**Re: Spring Creek North Continuation Project Information Request Response**

This letter has been prepared to address the Departments request for information (RFI) to assess the application to amend environmental authority EPML00370013 (application reference A-EA-AMD-100430427), issued to Rolleston Coal Holdings Pty Ltd (RCH) on 19th July 2023.

**Table 1** of this letter contains the RFI as provided by the Department, and the relevant response from RCH, incorporating information and advice from technical specialists. Section 2 contains additional supporting information, referenced within the **Table 1** responses.

Image Source: ESRI Basemap (2022) Data source: NSW LPI (2022), NSW DSFI (2022); NPWS Estate (2022)

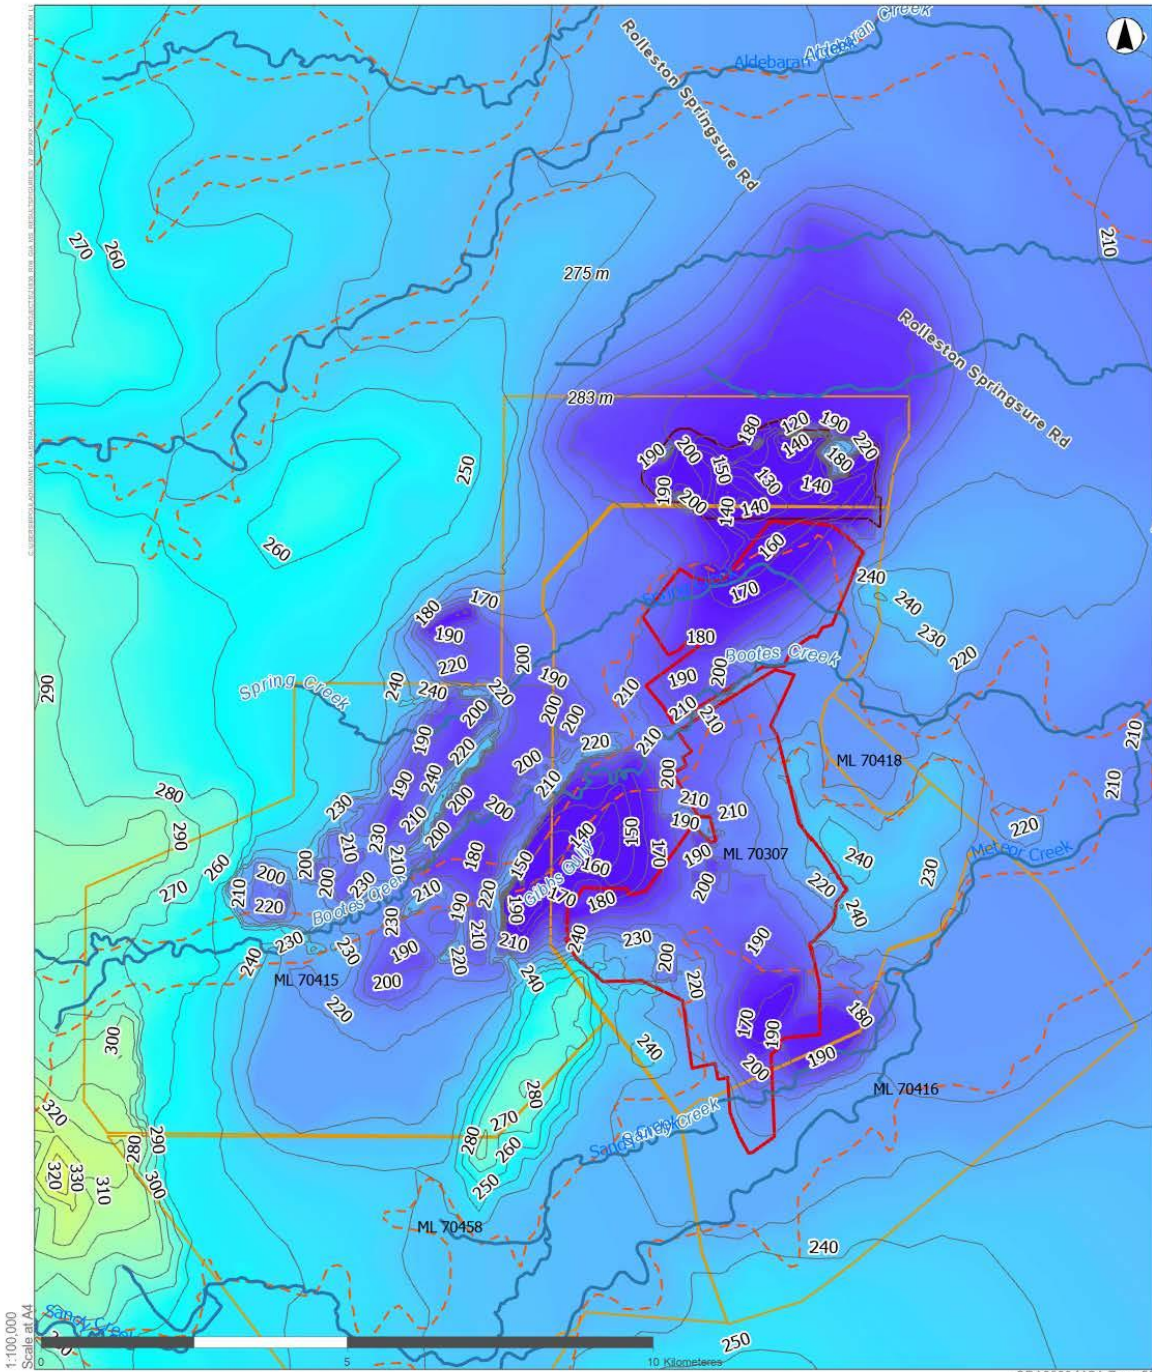
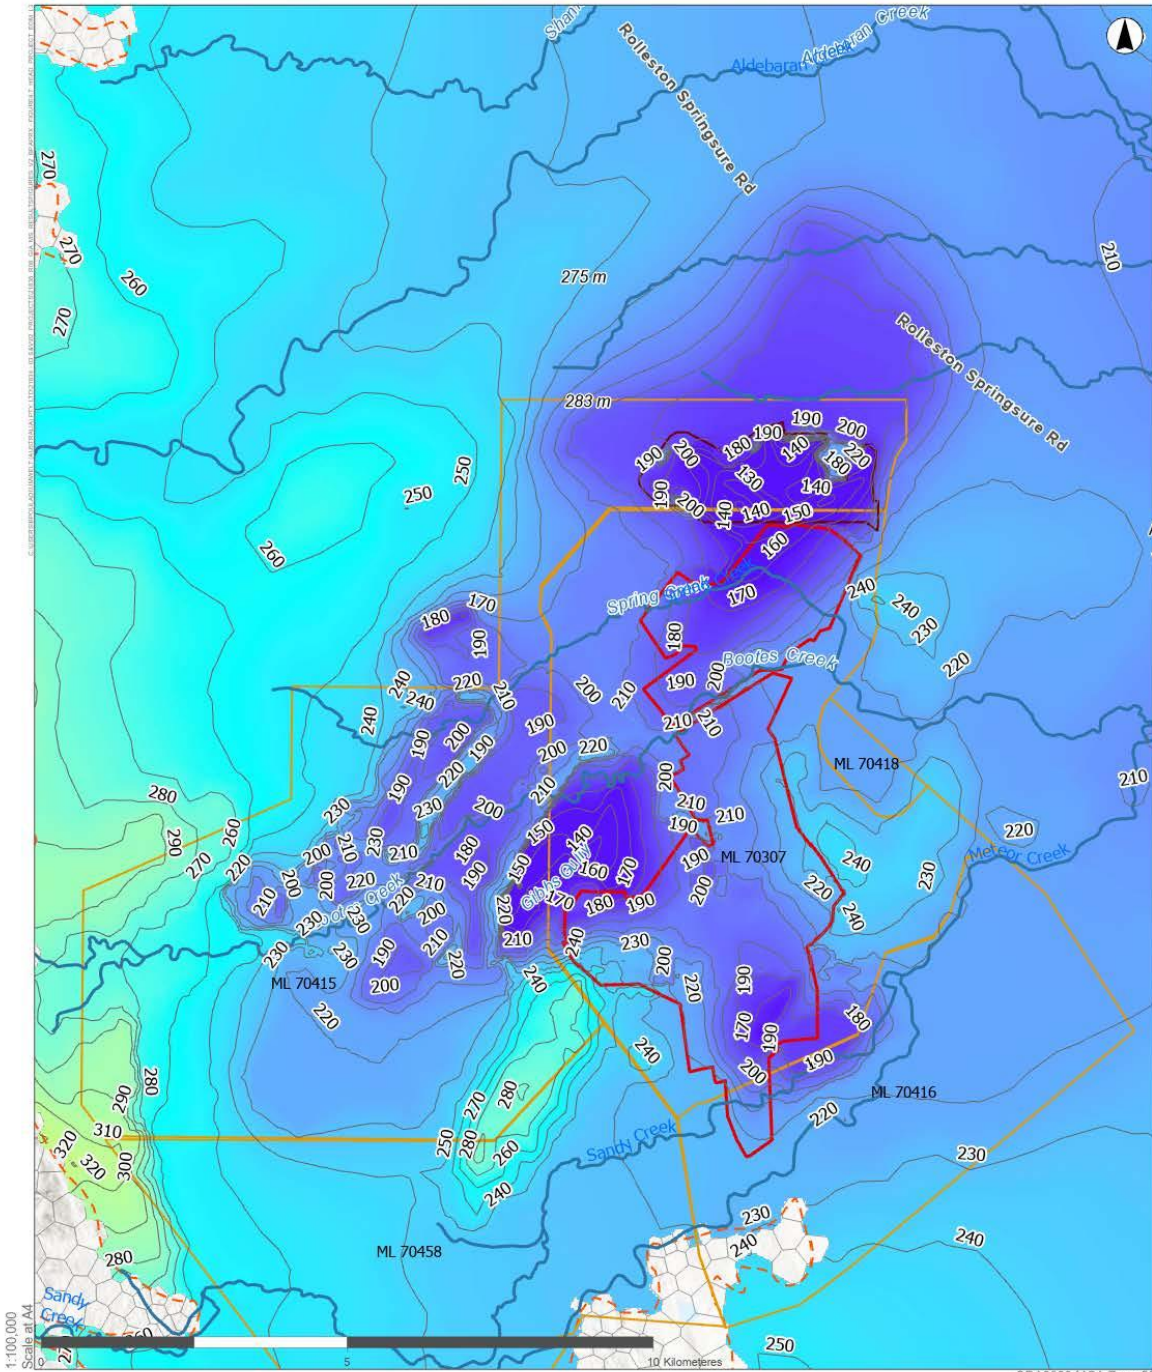
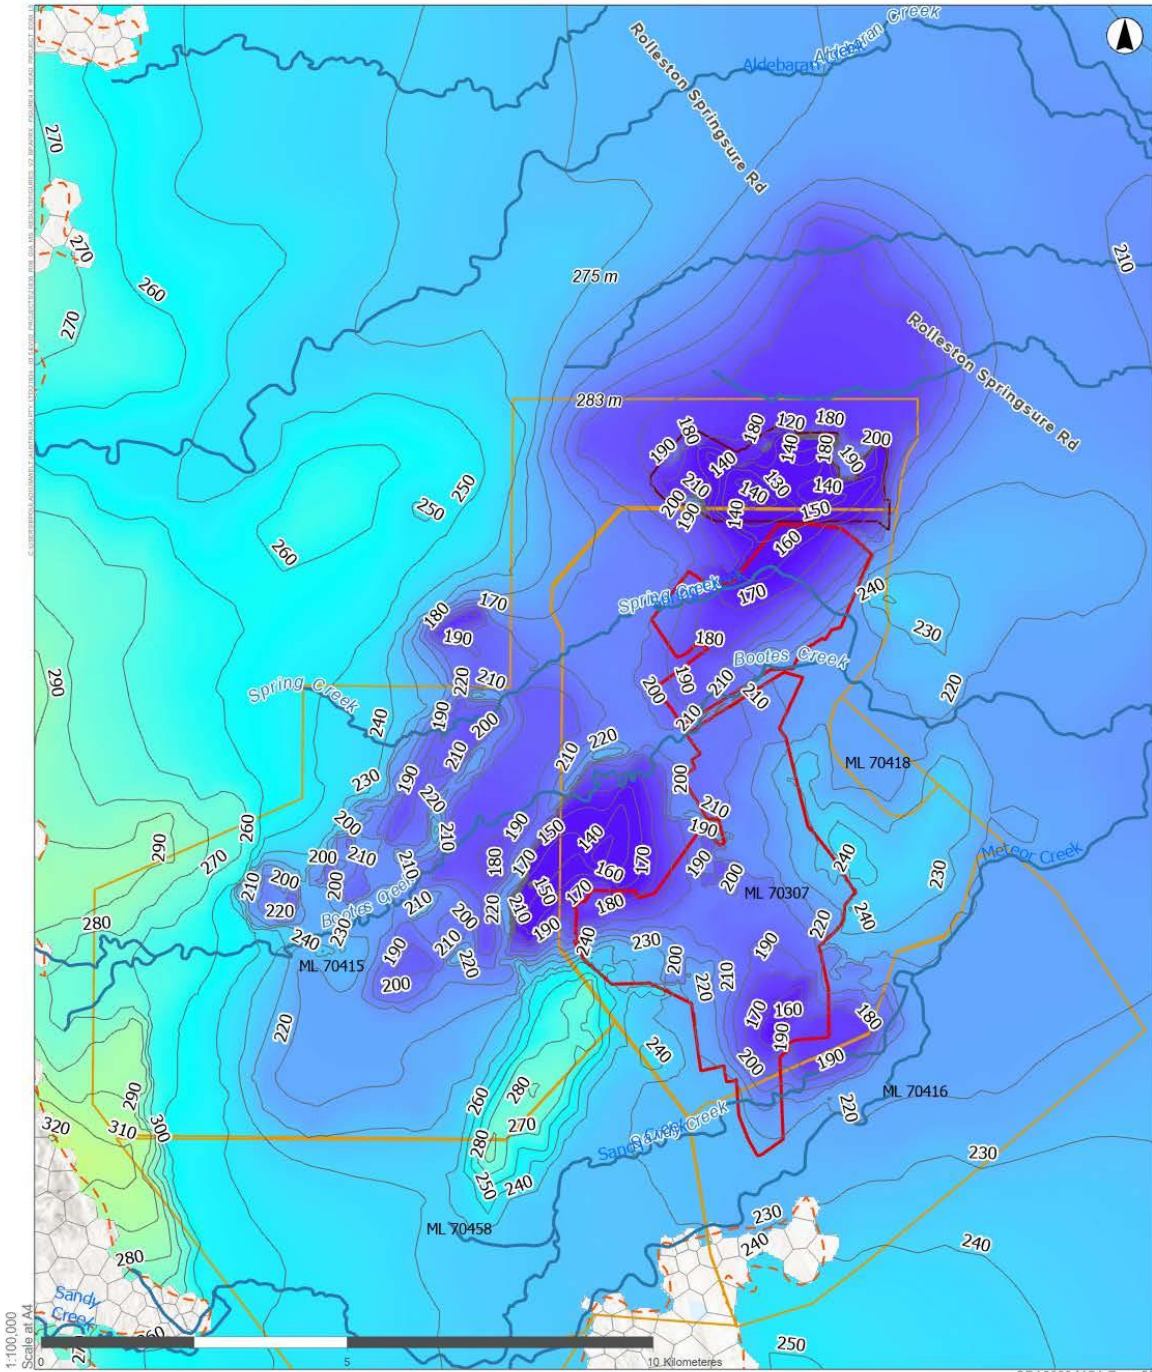
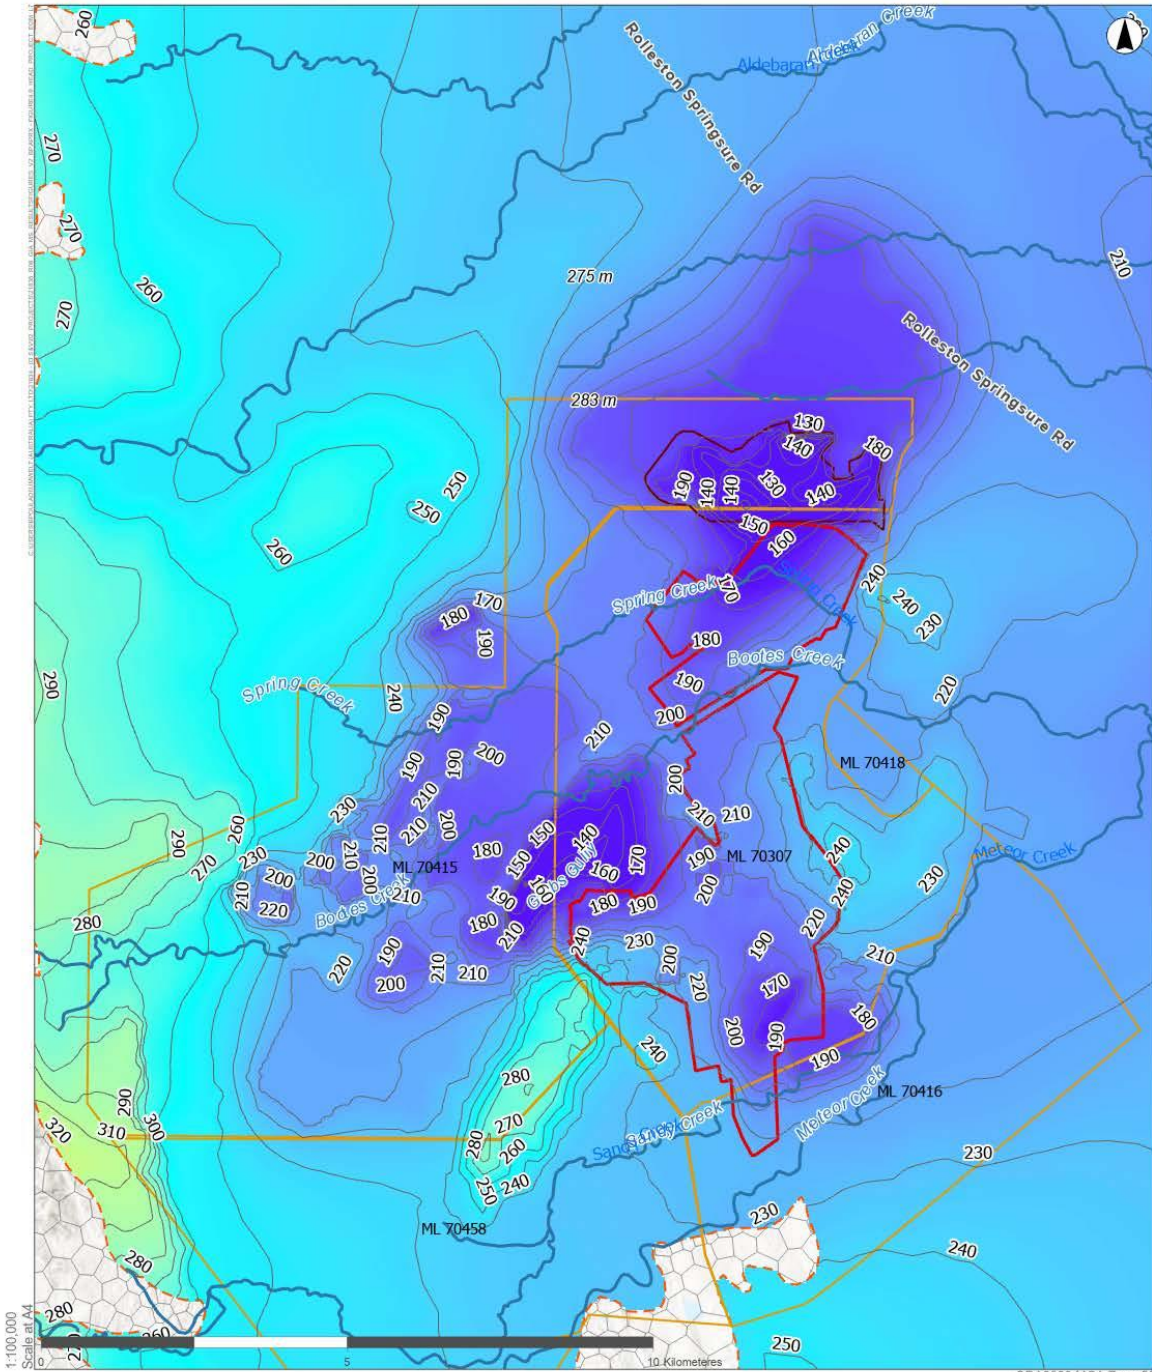
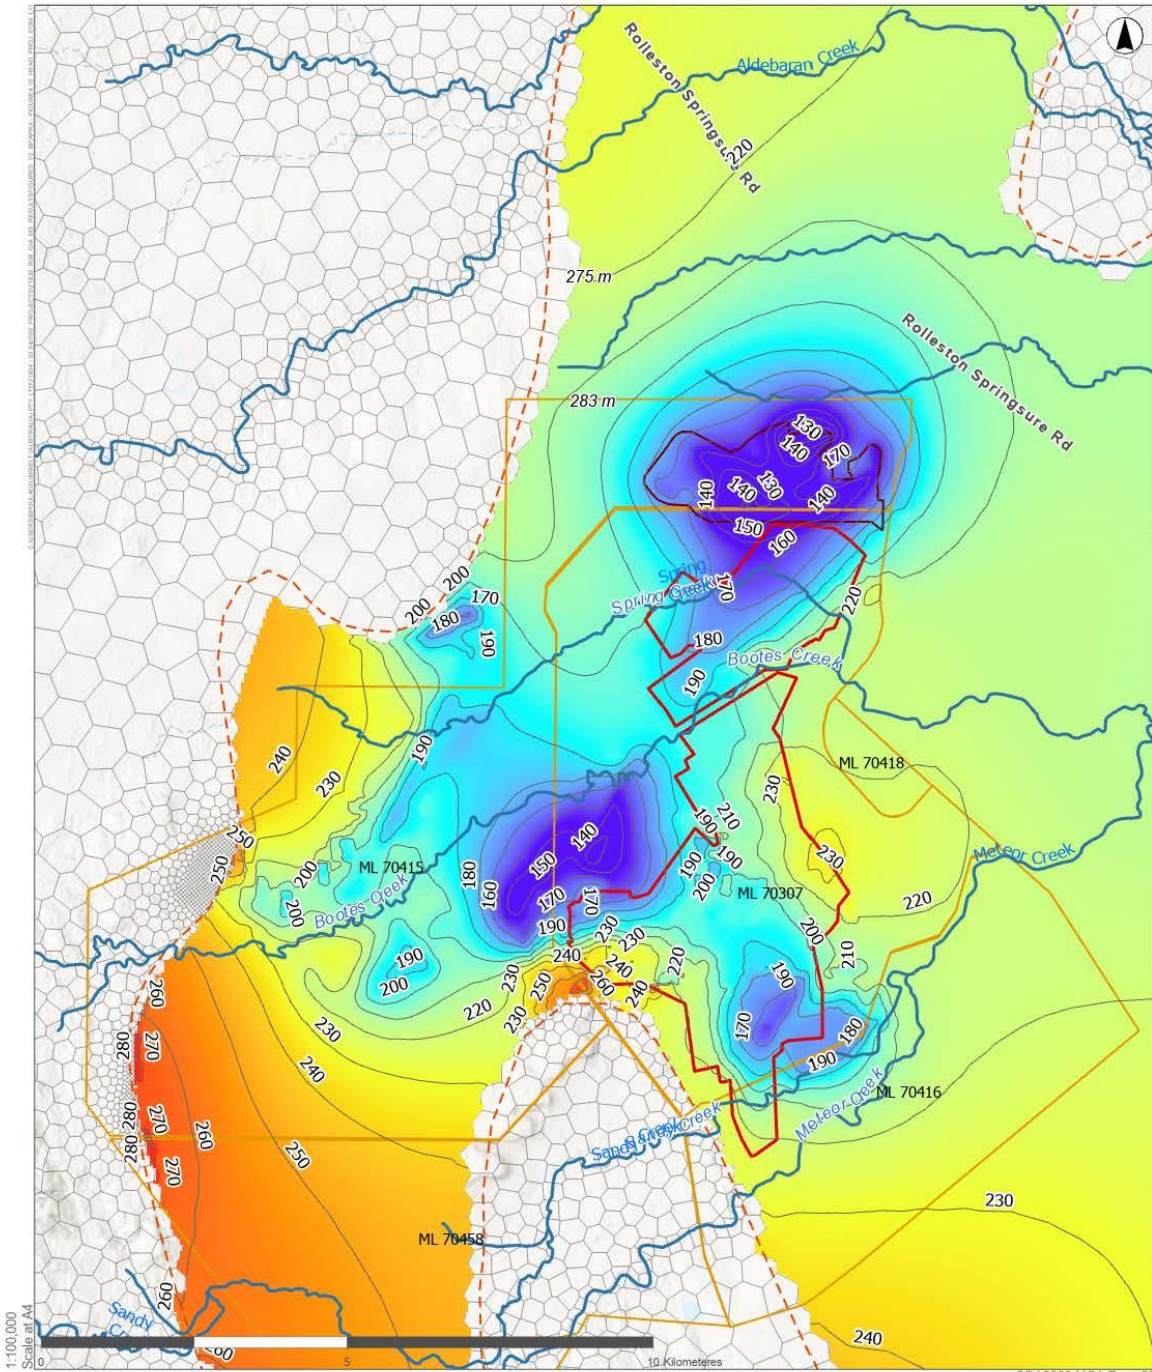
<p><b>11</b></p>	<p><b>Groundwater - Elevation Contours</b></p> <p>Appendix B Figures 4.1 to 4.10 provide predicted water level elevations in various layers at the end of mining, are presented at 50 m contour intervals and at a scale difficult to interpret around the mine and void areas.</p>	<p>Provide more detailed maps to allow the department to better understand the predicted groundwater level elevations at the end of mining.</p>	<p>Updated maps with greater resolution are presented in Section 2.7.</p>

Modelled groundwater levels at the end of the mining are represented in Figure 4.1 to Figure 4.5 below. This is based on the ‘Approved’ mine plan that represents the original mine plan modelled by AGE (2014) and approved operations at MDS, and extracted for Alluvium-Regolith (Layer 2) Tertiary Basalt (Layer 5) and D seam (Layer 11).

Modelled groundwater levels at the end of the mining for the Project are represented in Figure 4.6 to Figure 4.10 below, for Alluvium-Regolith (Layer 2) Tertiary Basalt (Layer 5) and D seam (Layer 11). The graphs have been updated to 1:100,000 mapping and include 10 m contours for the predicted groundwater head.
